February 2021
SF608A-D

Subject: Cascadia Road Train Brake System - Export Only

Models Affected: Specific Model Year 2020-2021 Freightliner Cascadia model vehicles, manufactured July 10, 2019, through September 14, 2020.

Specific Freightliner Cascadia right-hand-drive vehicles require a brake system modification in order to improve brake air release time, allowing for road train capability.

Fig. 34, Modulator Valve Delivery Port

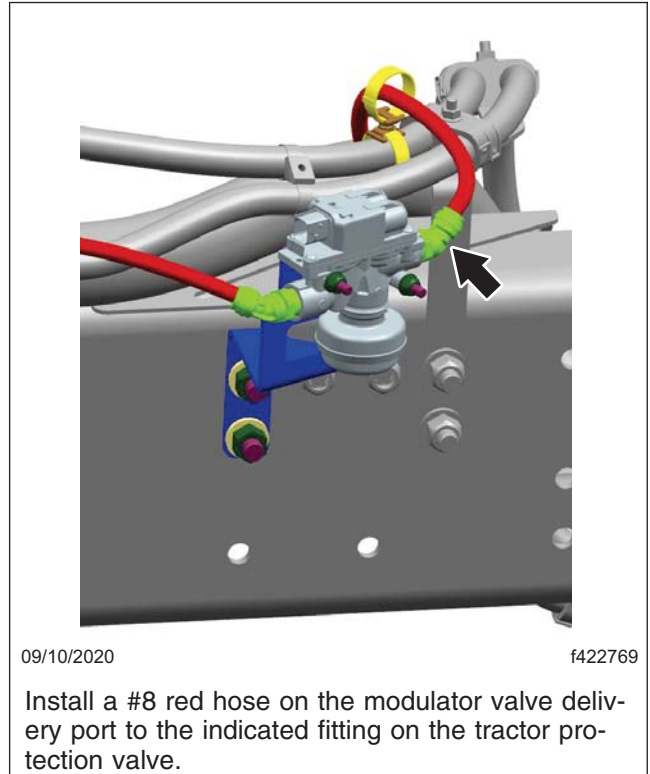
15. On the tractor protection valve, remove the red #8 hose from the fitting shown in [Fig. 33](#). Install a #8 red hose on the modulator valve delivery port to the indicated fitting on the tractor protection valve. See [Fig. 34](#).

Fig. 35, New Tractor Protection Valve Assembly

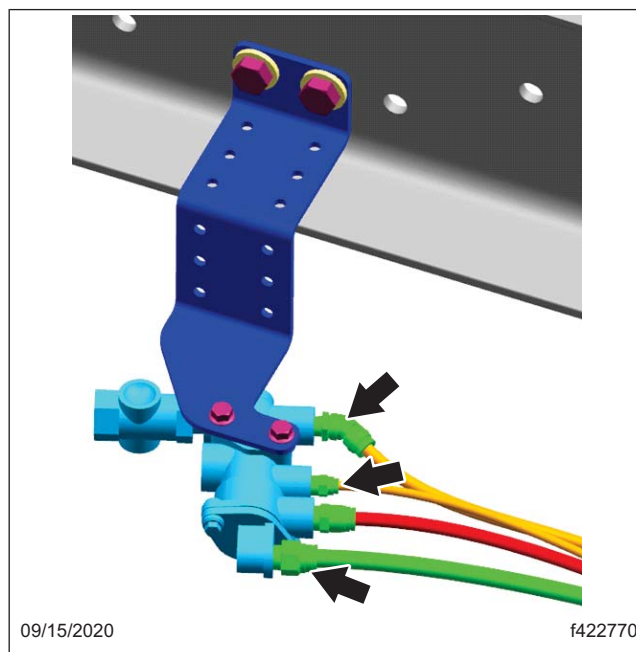
16. Shorten and attach the green hose and two orange hoses that were disconnected from the old trailer air assembly to the new tractor protection valve assembly as shown in [Fig. 35](#).

Fig. 36, Shortening the Black and Orange Hoses

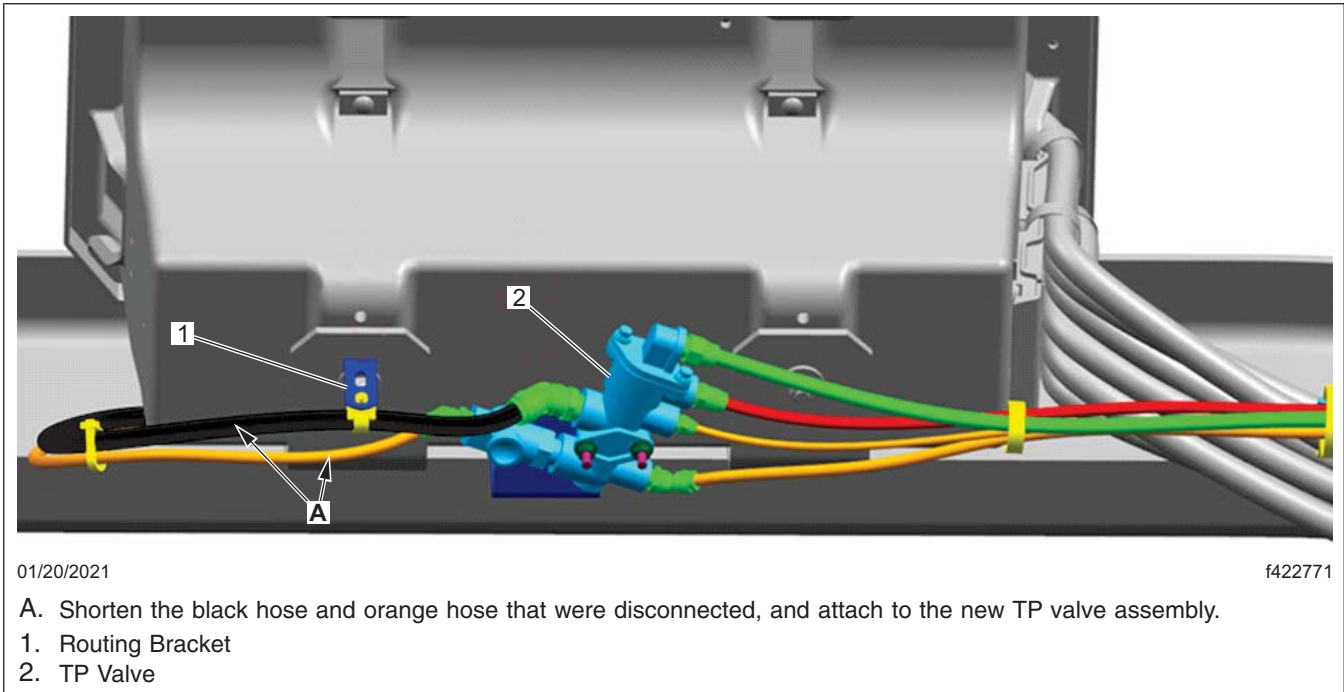
17. Shorten the black hose and orange hose that were disconnected, and attach to the new tractor protection valve assembly. Install the routing bracket on the rear battery box mount. See [Fig. 36](#).
